# Product Change Notification (PCN): 0025 Apalis T30 2GB V1.1B, 0026 Apalis T30 V1.1B and 0031 Apalis T30 1GB IT V1.1B to versions V1.1Z

Date of publication: 25 Apr 2023

#### **Change #1: Removal of Level Shifter**

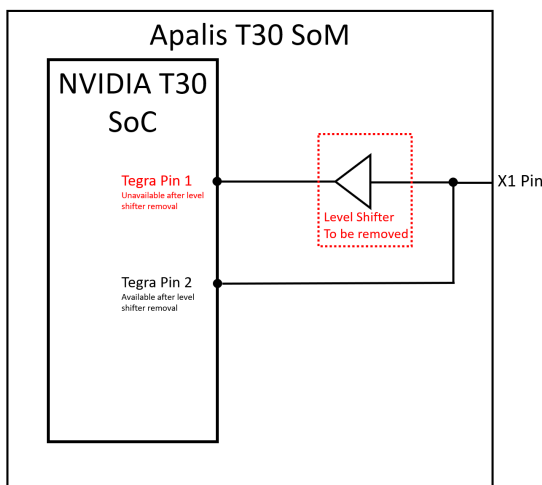
- Removed TI 74AVCA164245ZQLR and related components due to component EOL and shortage

- Parallel camera interface won't be available in V1.1Z
- No changes are required on the Apalis carrier board
- SoM Pins affected by this change are : 99, 123, 135, 159, 173, 175, 177, 179, 181, 183, 185, 187, 191, 195, 197 (Figure 5 and Table 5-54 in [Apalis T30 datasheet](#))
- All the affected SoM pins multiplexed. They are connected to 2 pins on the SoC-side (see Table 4-1 - Apalis T30 Multiplexed Pins in [Apalis T30 datasheet](#))

- The removal of the TI 74AVCA164245ZQLR does not impact the functionality of software, i.e. no errors are displayed
- Coming out of Reset, some of these pins will have the internal pull-up/down enabled (for more details see Section 4.4 - List Functions in [Apalis T30 datasheet](#))
- After boot, If not handled properly, the affected Tegra pins listed above will be left floating as a direct consequence of removing the TI 74AVCA164245ZQLR level shifter. Thus, Toradex strongly recommends enabling the pull-down resistor on these Tegra pins (see related [developer website guide](#))
